Application for Works Approval Amendment

Part V Division 3 of the *Environmental Protection Act 1986*

Works Approval Number	W6327/2019/1
Works Approval Holder	BHP Billiton Iron Ore Pty Ltd
ACN	008 700 981
File Number	DER2019/000568
Premises	Mining Area C – Ore Handling Plant 3 WWTP Mining Leases ML284SA and ML249SA NEWMAN WA 6753 As defined by the Premises map attached to the Revised Works Approval
Date of Report	3 September 2020
Decision	Revised works approval granted

Figure 1: Location of WWTP and irrigation field

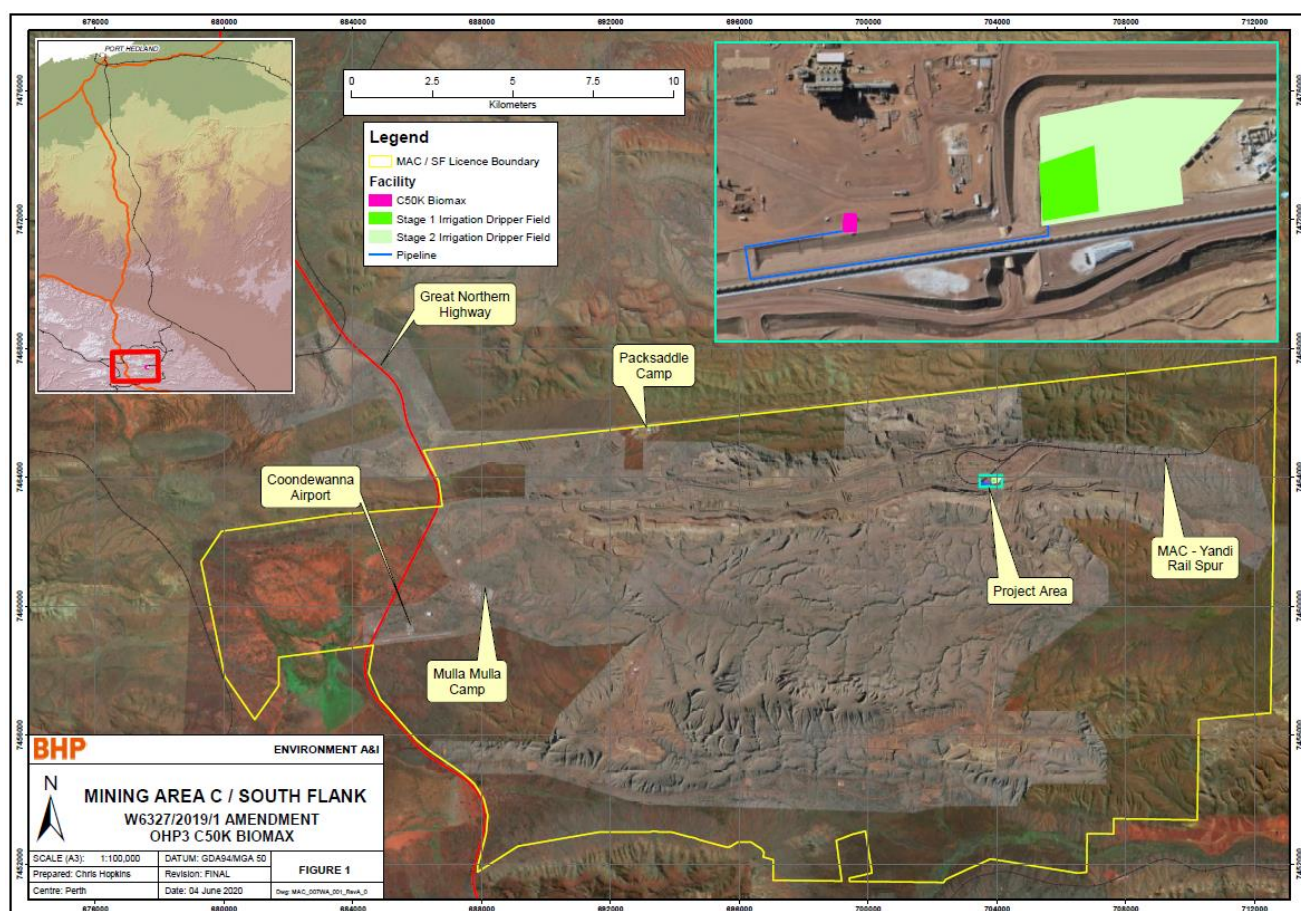
The works approval holder has identified that additional future facilities may be plumbed in to the OHP3 WWTP which will increase the expected treated waste water discharged. To accommodate these potential future increases in discharge volume the works approval holder is seeking to add a second stage to the construction of the irrigation field to increase it from 5,120 m² to a total of 9,125 m² (increase of 4,005 m²). This will ensure that if the WWTP was operating at full capacity (50 m³/day) the irrigation field would be sufficiently sized to accommodate the discharge (using the revised expected water quality values) to maintain compliance with WQPN22 nutrient loading guidelines (480 kg/ha/yr of Nitrogen and 120 kg/ha/yr for Phosphorous). DWER's calculations confirm that the total field size of 9,125 m² is the minimum size necessary for the revised quality and proposed discharge rate of 50 m³/day.

The works approval holder intends to construct, commission and operate Stage 1 of the irrigation field prior to the construction of the Stage 2 irrigation field.

Figure 1 below shows the location and layout of the WWTP and irrigation fields for each stage of construction.

Ref	Infrastructure or Equipment	Site Layout Plan reference (Figure 1)
Stage 1 of construction (already approved under W6327/2019/1)		
1	Packaged C50k Biomax WWTP with capacity of 50 m³/day, consisting of an anaerobic chamber, aerobic chamber, clarification chamber, disinfection chamber and pump-out chamber. Packaged WWTP will include alarms to provide warning of the failure of the air compressor and discharge pump. WWTP to have approximately two days of in build storage to prevent overflow in the event of failure of discharge pump.	C50K Biomax (pink)

2	Irrigation spray field 5,120 m ² in size; Sub-soil drippers to be installed; 10 cm earthen bund installed around perimeter of irrigation spray-field; and Fence with safety signage installed to deter access. Field to be fenced and surrounded by a 10 cm earthen bund.	Stage 1 Irrigation Dripper Field (green)
3	560 m long pipeline to transport effluent from the WWTP to the irrigation spray field.	Pipeline (blue)
Stage 2 of construction (the subject of this amendment)		
1.	Expand irrigation spray field constructed under stage 1 by 4,005 m ² to a total area of 9,125 m ² ; Sub-soil drippers to be installed; 10cm earthen bund installed around perimeter of irrigation spray-field; and Fence with safety signage installed to deter access.	Stage 2 Irrigation Dripper Field (green)
